Sub: Corrigendum-01: Amendment to Tender specification document & due date extension

- 1. E-Tender specification No: 2101094
- 2. **Scope of work:** Detailed drawing preparation based on Input design drawings provided by BHEL-Engineering Centers for Flue Gas Desulphurization (FGD) Package as specified in scope and getting approval from BHEL- Engineering Centers/ NTPC. Fabrication and supply of finished product (procurement of raw structural steel will be in the scope of bidder) i.e. structures of FGD as per BOM/Drawings at 2X500 MW NTPC Mauda, Stage-I, TPP-FGD, Maharashtra.

2 X 500 MW MAUDA STPP-FGD PACKAGE			
DWG / DOC NO AND TITLE : 9561-109-ISG-PVC-B-445 - CONVEYOR LBC-1AB-GA OF GALLERY & TRESTLES R0				
SL NO	NTPC COMMENTS	BHEL REPLY		
1	Hold	Staad file has been revised and errors resolved		
2	PTFE bearing shall be provided for slinding support	Accepted. PTFE indicated in elevation view.		
3	COMPLY TO COMMENTS MARKED DESIGN DOCUMENT	Complied		
4	DESIGN/DRAWING TO CONFORM TO LATEST MECHANICAL/ELECTRICAL GADRG.	Accepted. Trestle Tr-2A introduced for structural requirement, after discussion with mechanical. The same will be updated in Mech GA dwg.		
5	ALL FURTHER CHANGES TO BE I

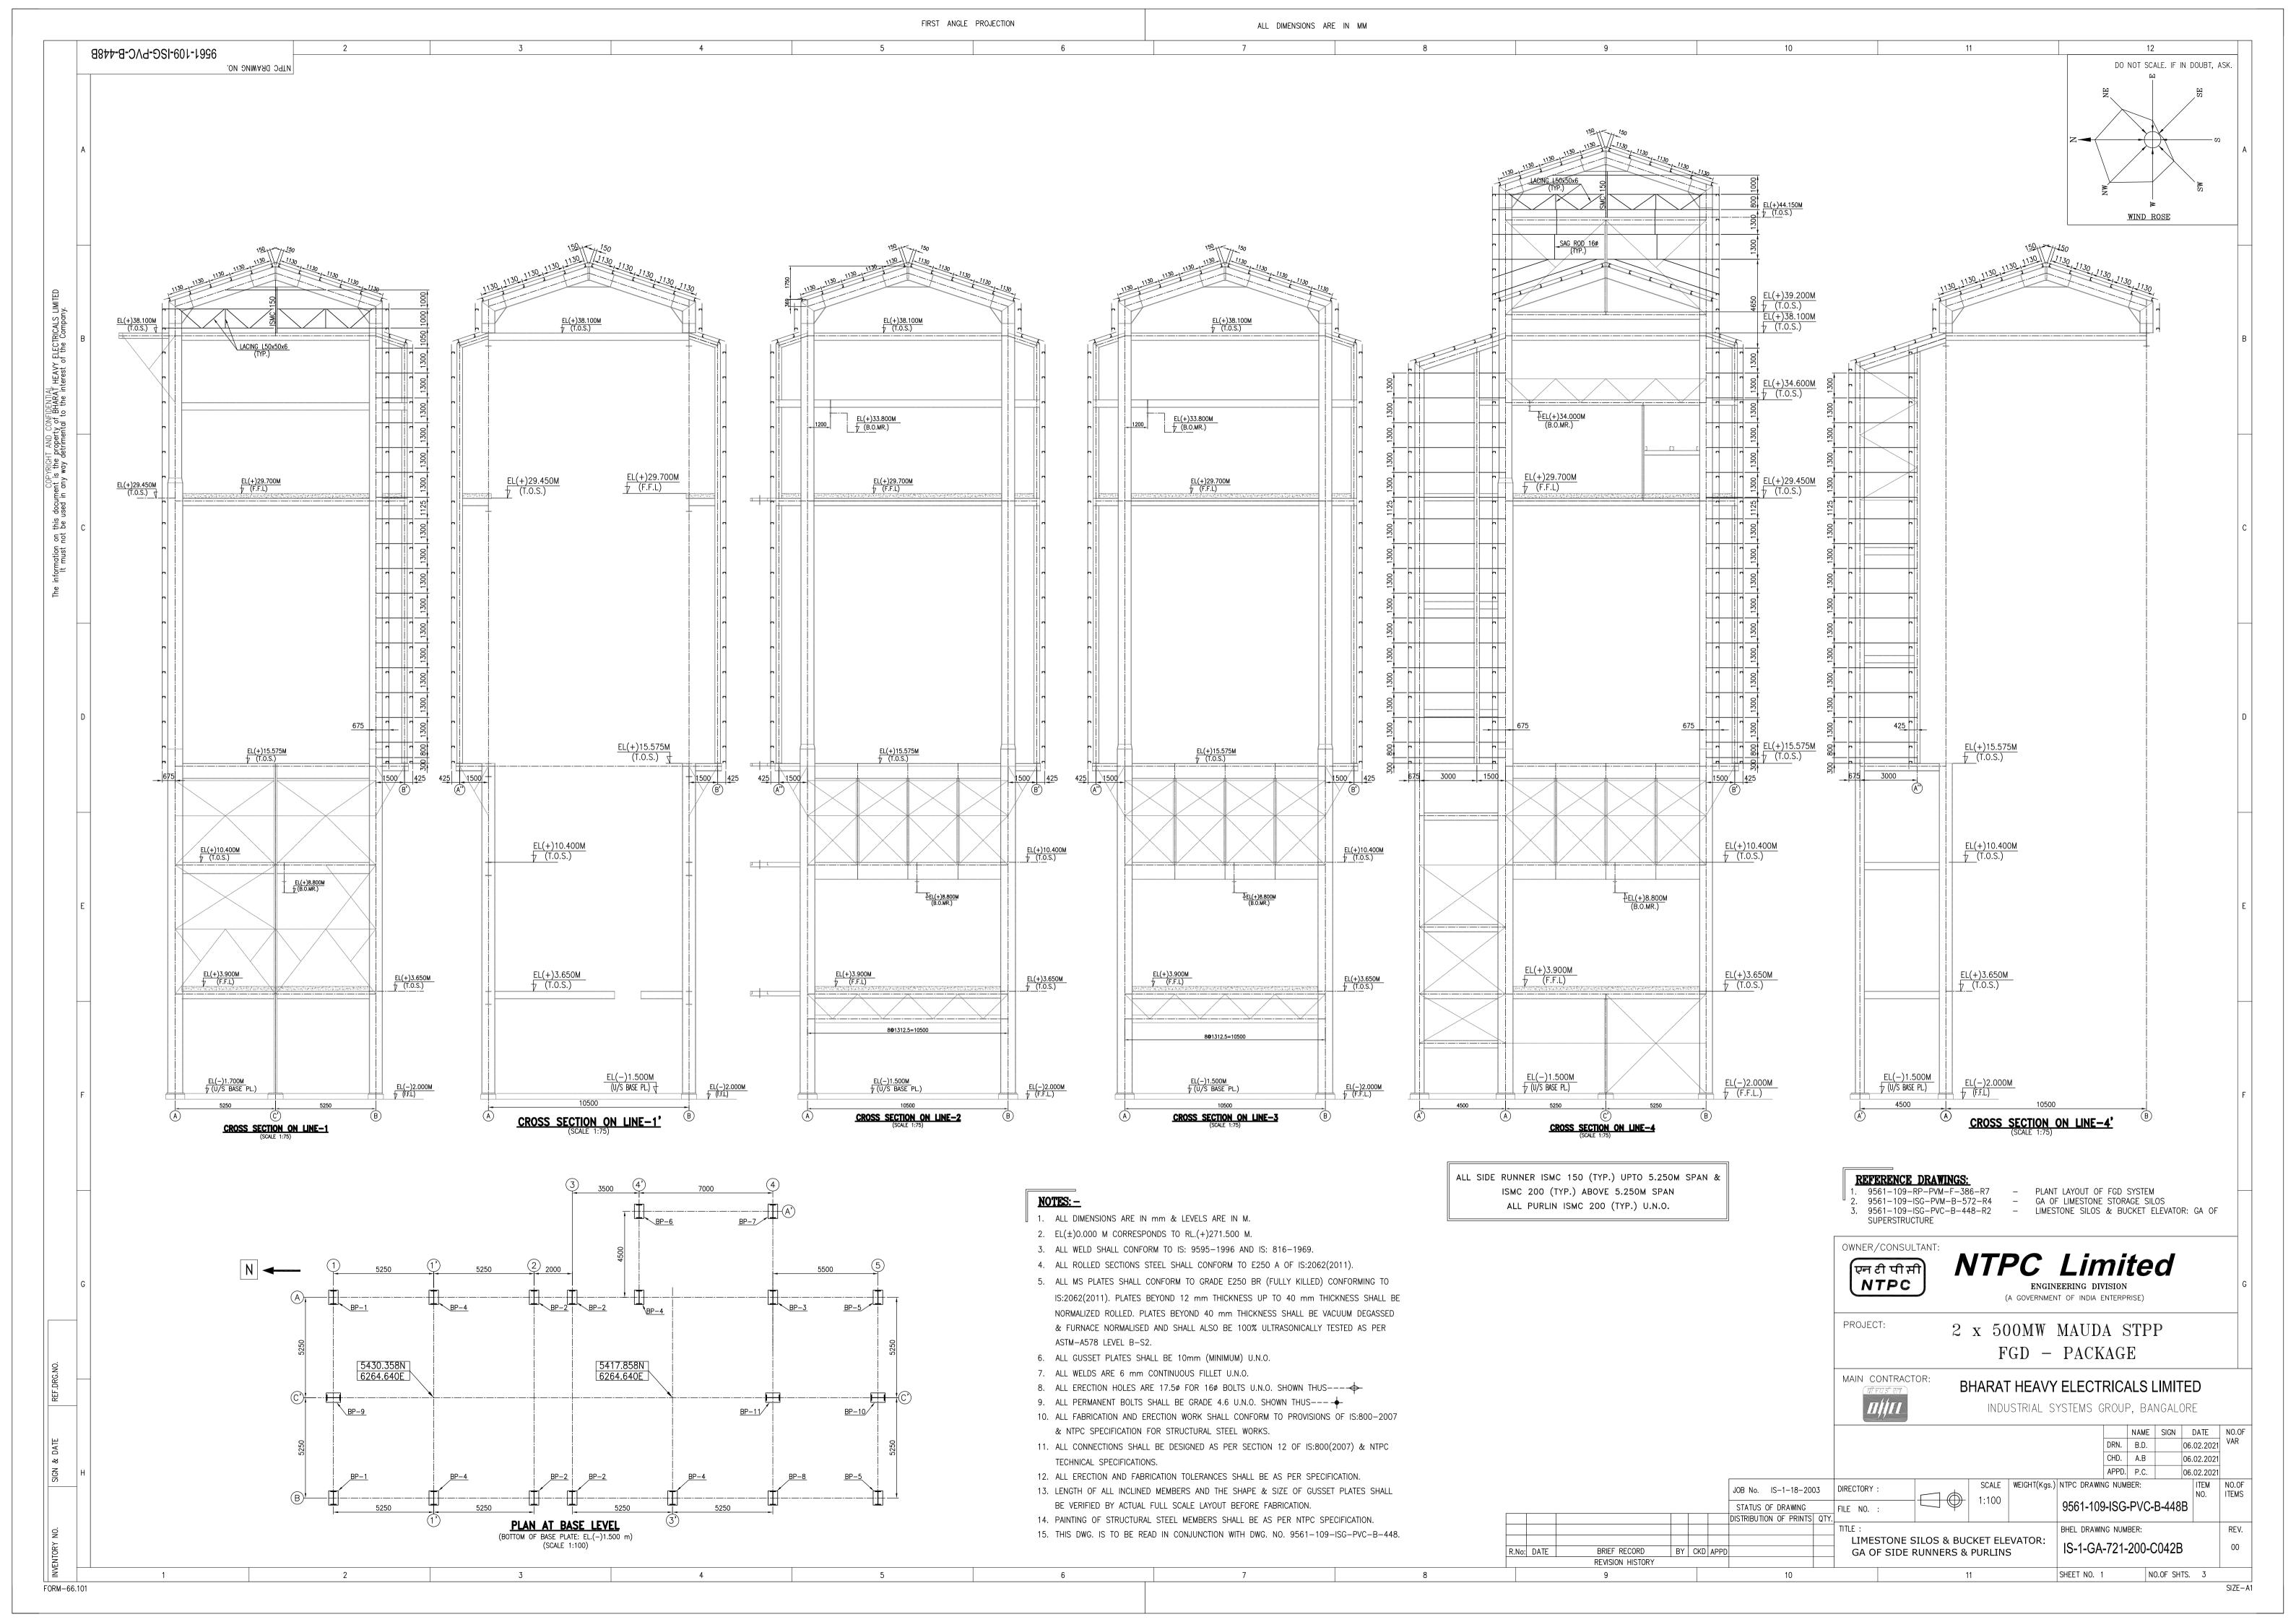
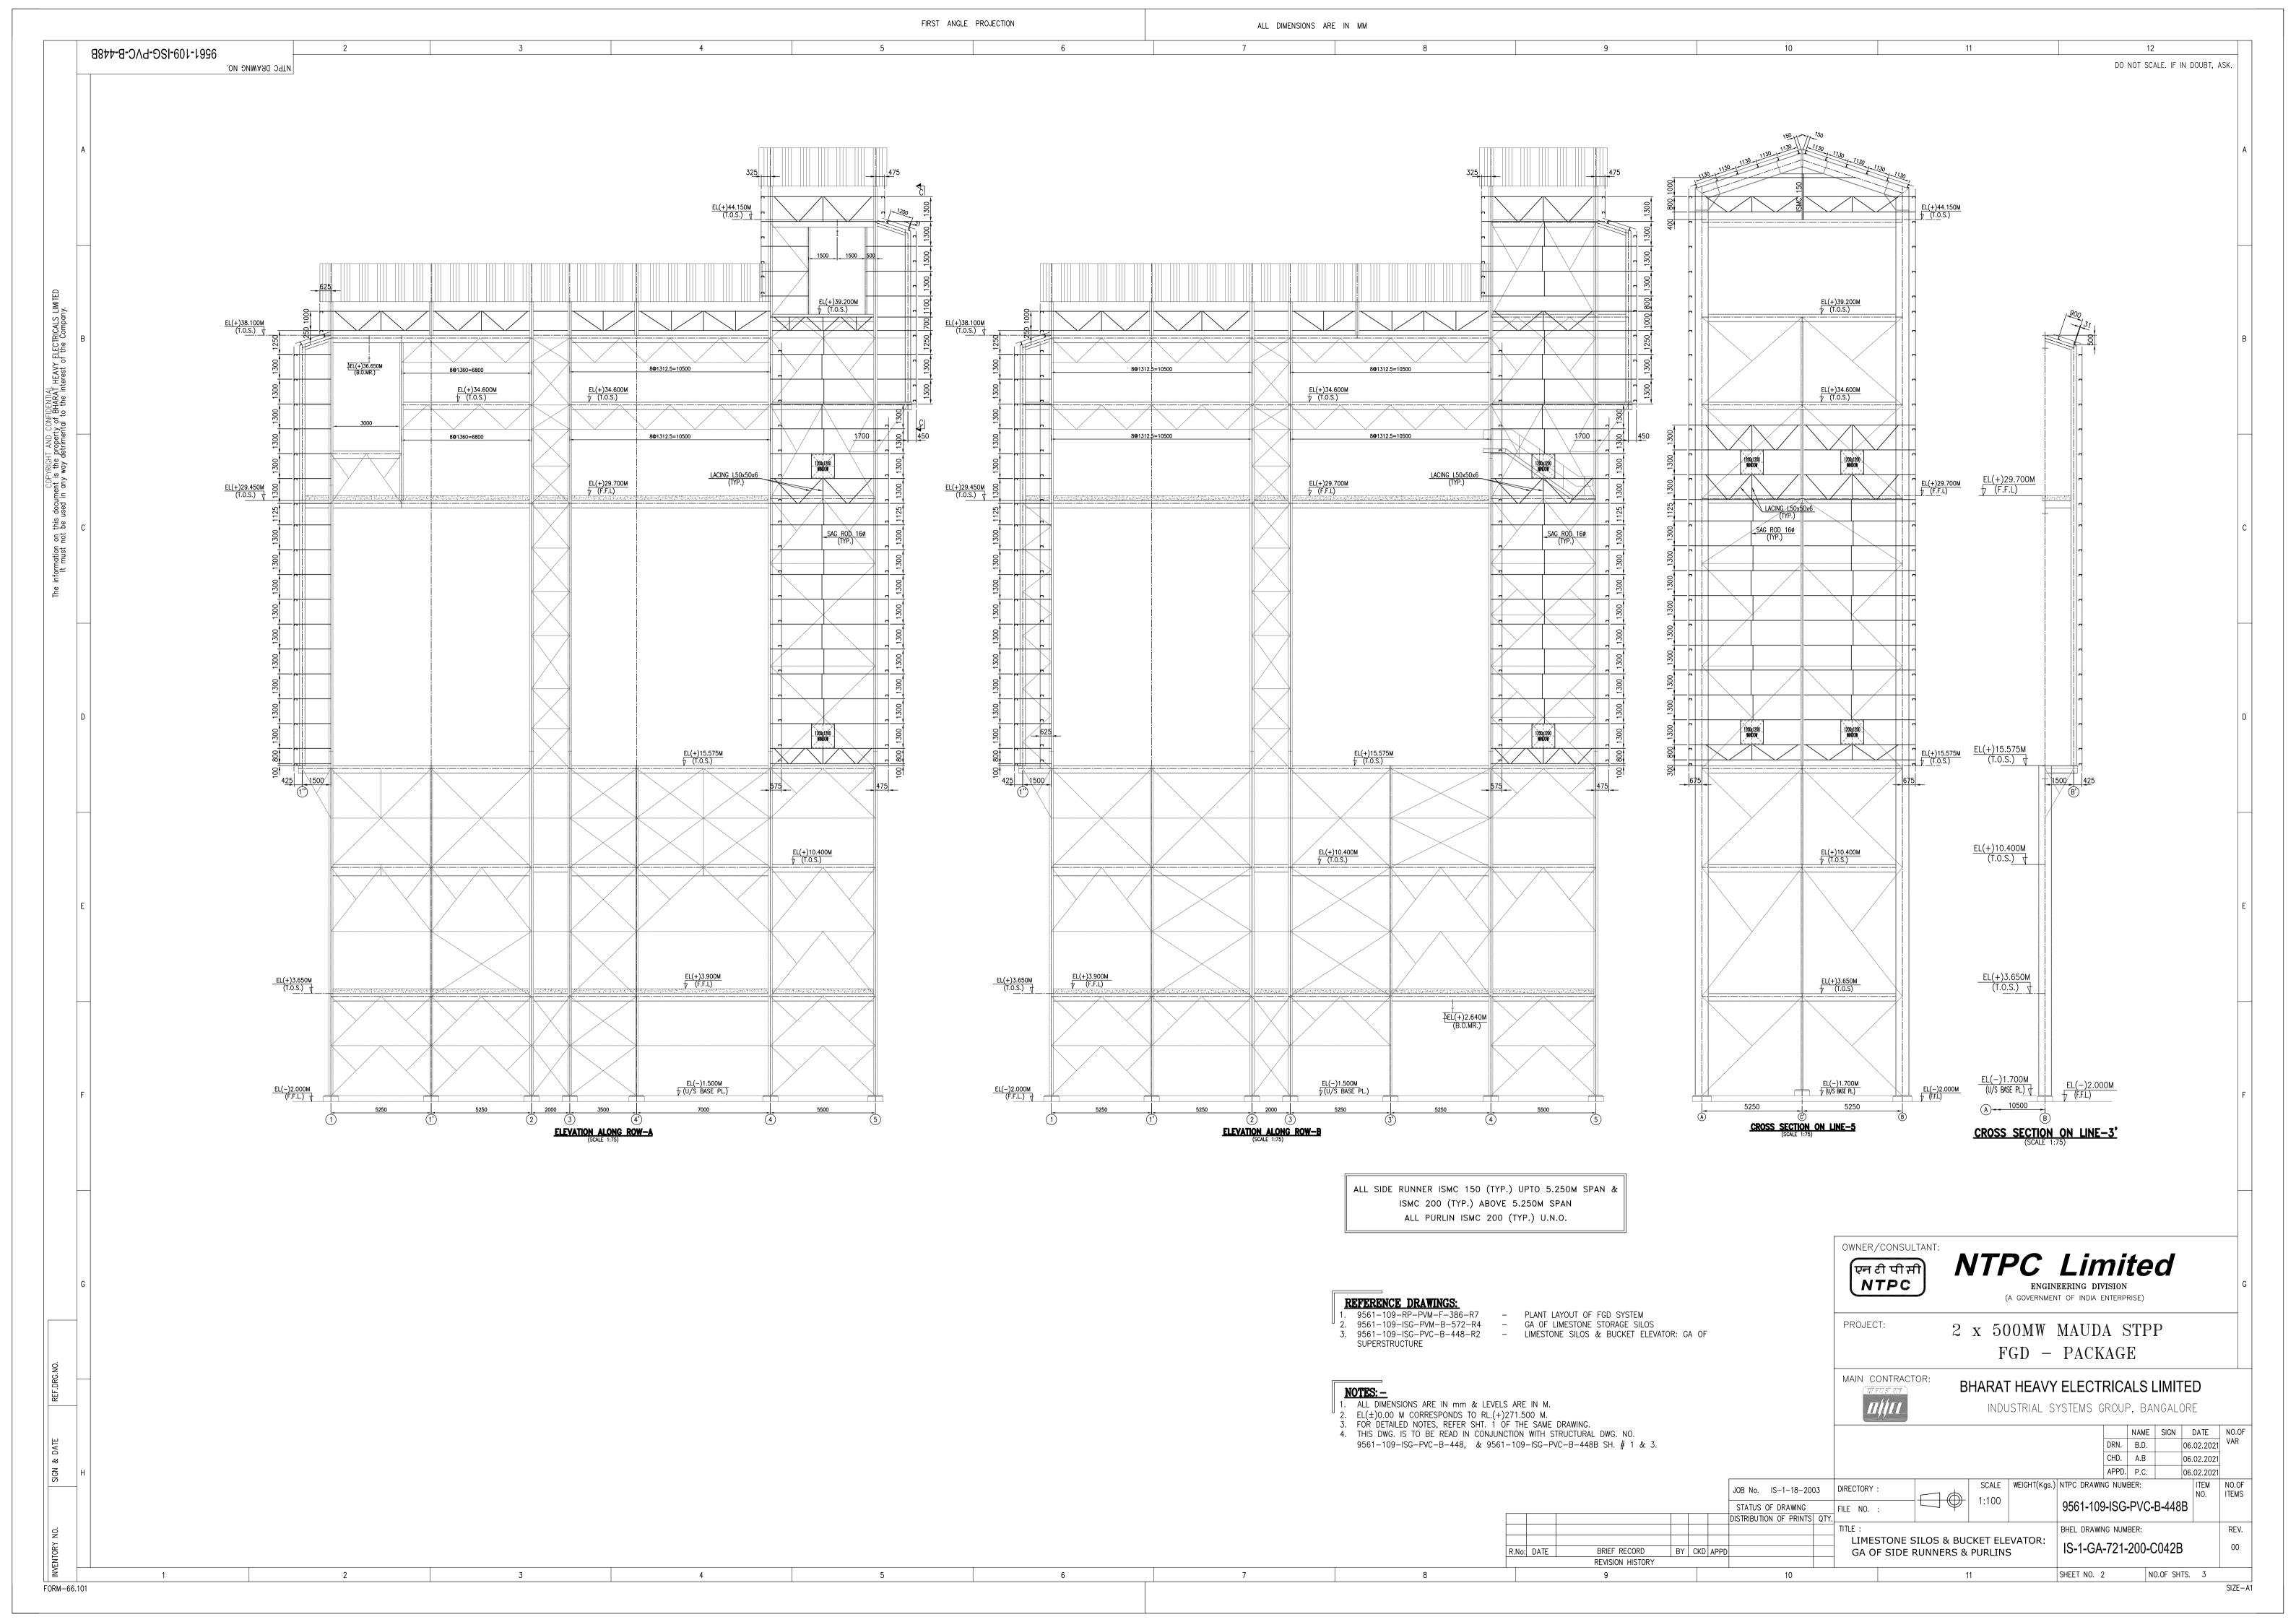
8	Design and Detailing of connections shall be done as per section 10 and section 12 of IS 800:2007.	Ok. The same has been incorporated in Notes
